**08-AFC-2**

**DATE:** September 17, 2009  
**To:** California Energy Commission  
Docket Office - #08-AFC-02  
**FROM:** Lois Navarrot  
**SUBJECT:** Beacon Solar Energy Project  
**ENCLOSED PLEASE FIND:** Beacon Solar, LLC's E-Mails and POS

**From:** Foster, Jared  
**Sent:** Friday, September 04, 2009 5:26 PM  
**To:** Eric Solorio  
**Cc:** Stein, Kenneth; McCloud, Duane; Russell, Meg; Busa, Scott  
**Subject:** Beacon Solar Energy Project - Revised Grading Plans

CLIENT/PROJECT TITLE  
BEACON SOLAR, LLC  
BEACON SOLAR ENERGY PROJECT

PRELIMINARY CONCEPTUAL  
RETENTION POND PLAN  
PLAN VIEW

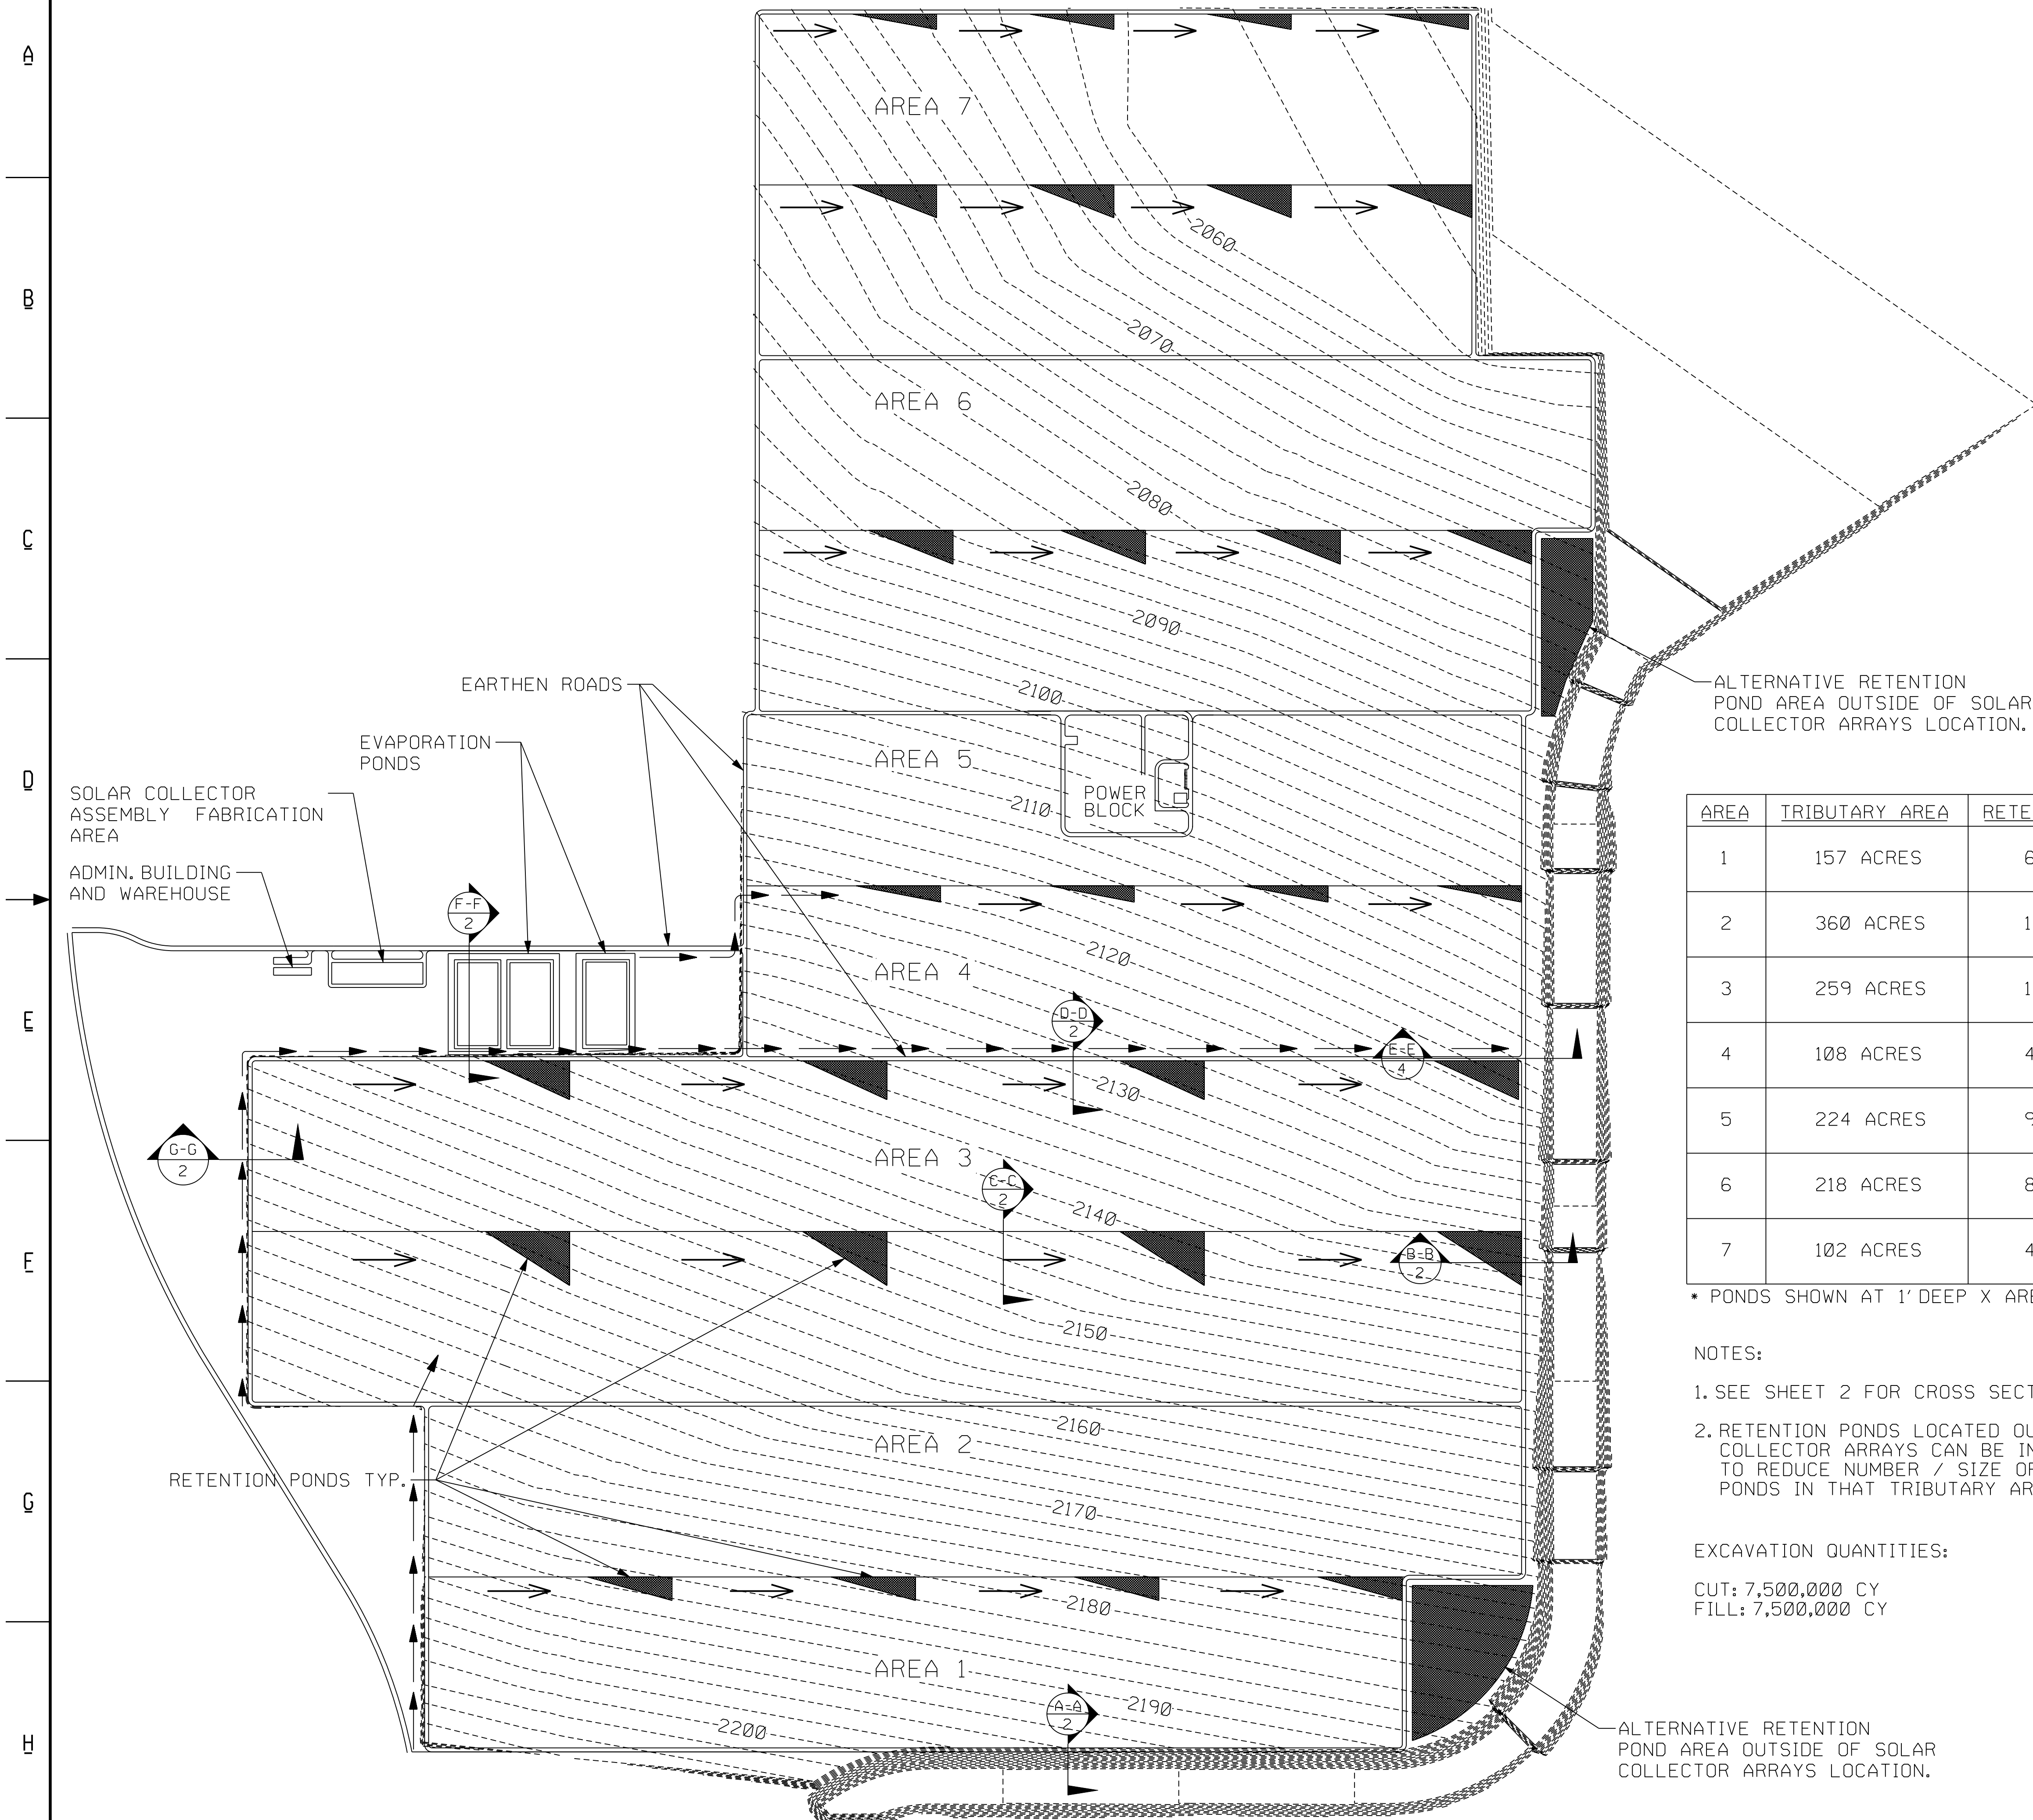
Eric - Attached are the revised grading plans for the Beacon Solar Energy Project. They differ from Figure 12 in the Project Refinements document to the extent that the grading plan is broken into two sheets. The first sheet is the grading plan and the second sheet provides section details. Cut and Fill numbers are shown on sheet one under the notes.

CUT: 7,500,000 CY  
FILL: 7,500,000 CY

**Figure 14A**  
**Changes in Water Level (ft)**  
**After 5 Months of Construction**  
**Pumping at Well 48**  
**(Revised Volume - Reflecting Changes**  
**in the Proposed Grading)**

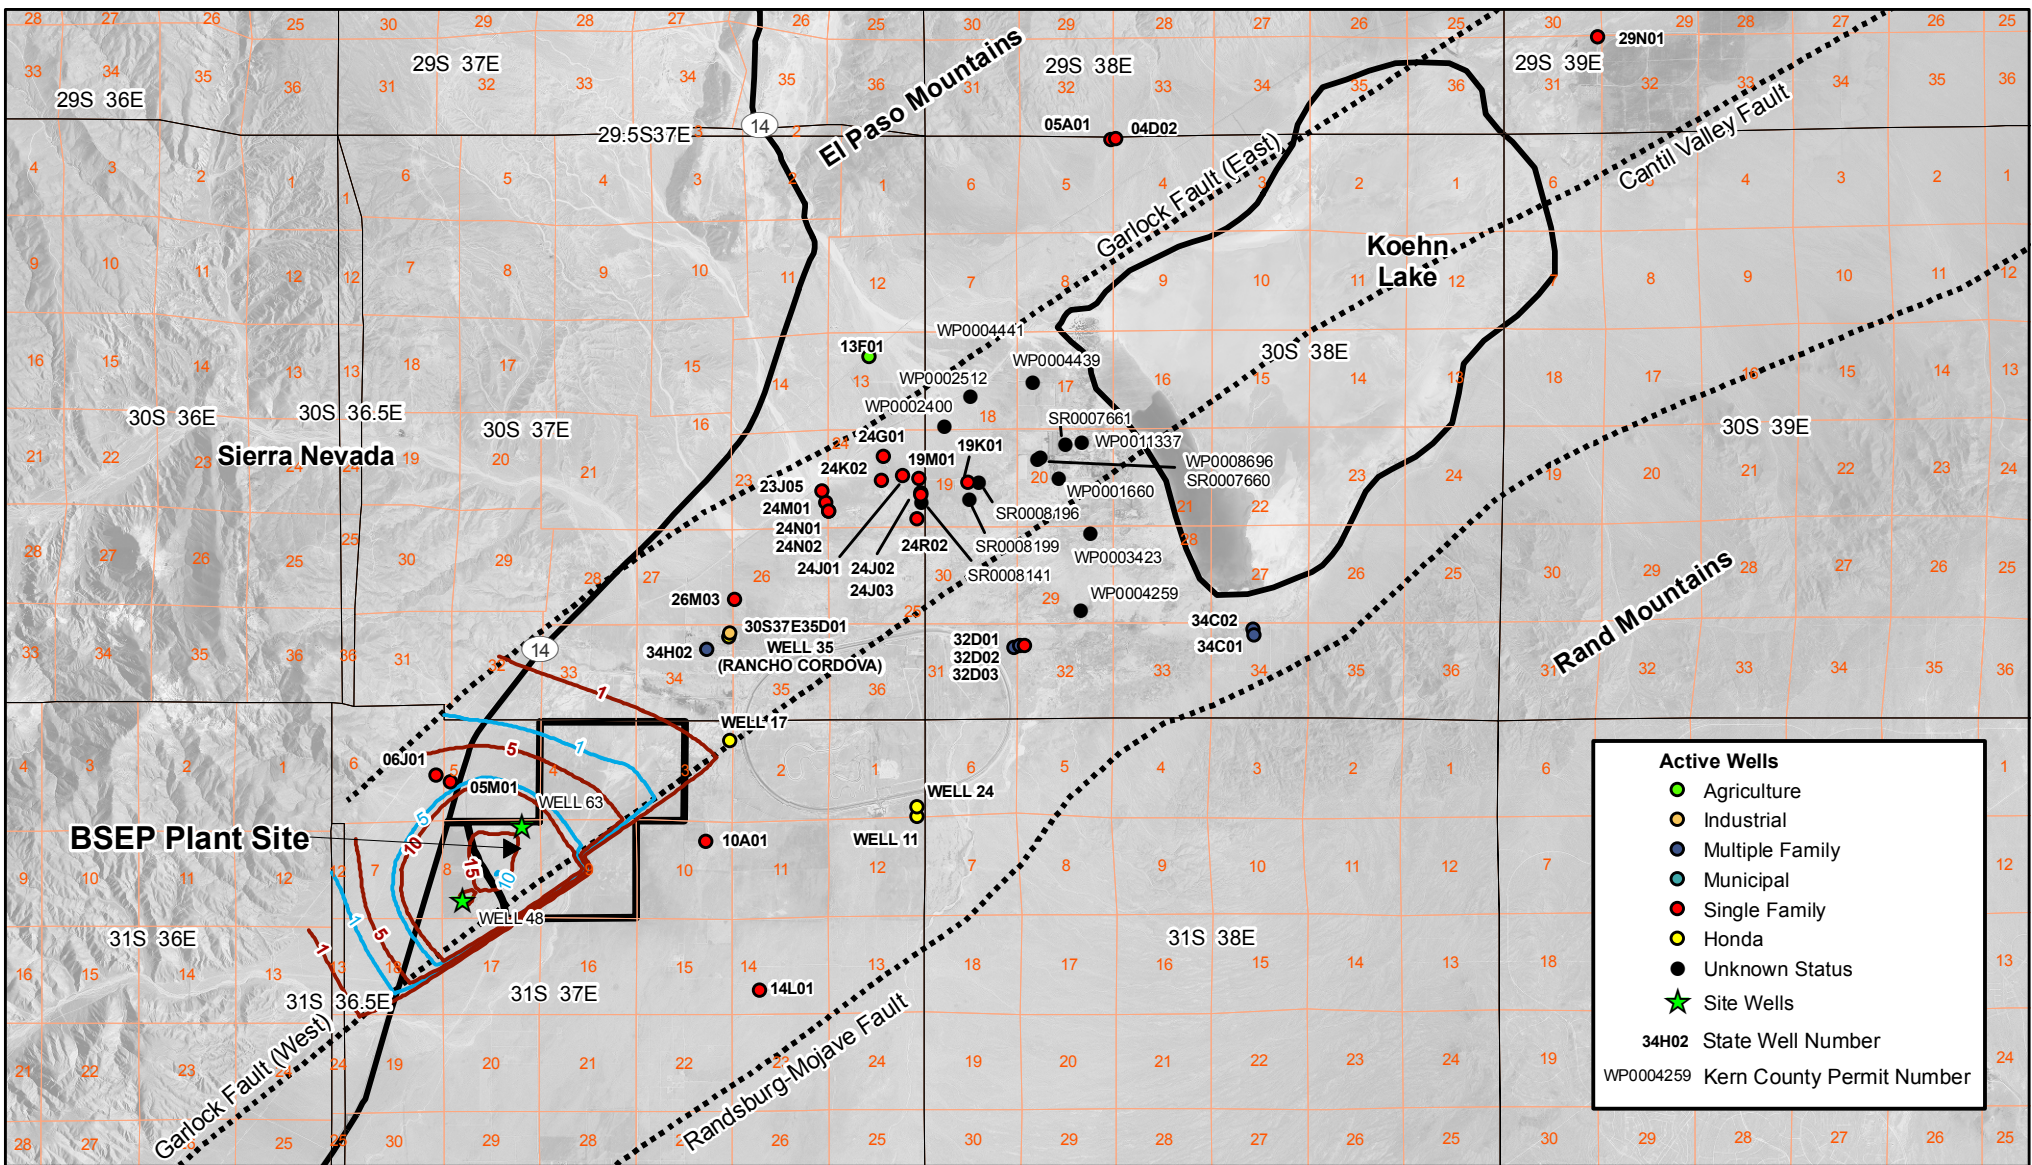
The attached Figure 14a, shows radius of influence and the difference between the proposed construction water use during the 5 month grading period for the prior proposed water use (~2,500 af) and revised volume (~3,300 af). The model results are not significantly different and do not predict any additional wells will be affected by the increased pumping volume over the short duration when water is needed for grading. Of note, water use beyond the grading period will not be different than as provided in the AFC.
